External Review of Nodal Program PMO Control System

Executive Discussion

Electric Reliability Council of Texas,
Inc. (ERCOT)
Board of Directors Meeting
February 19, 2008

Incomplete Transition Plans and No Transition Plan Staffing

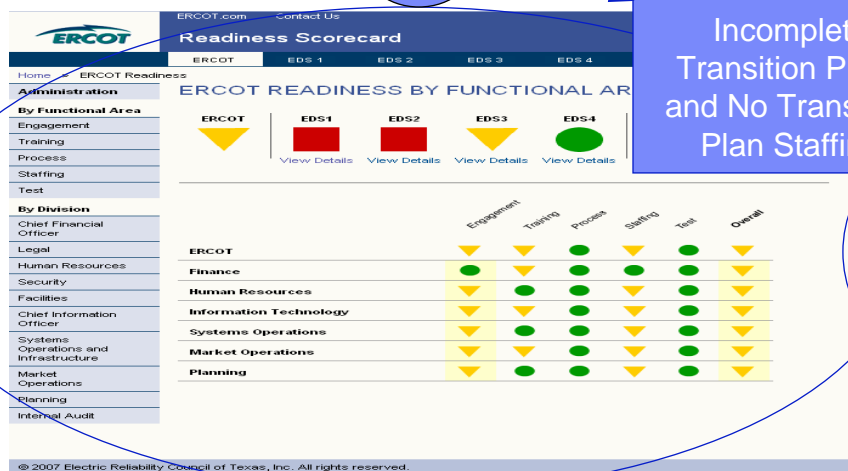
Typical milestones for transition are rapidly approaching; readiness is lagging

- ✓ Complete and Staff Transition Plans
- ✓ Fill open Nodal Consulting/Contractor Positions
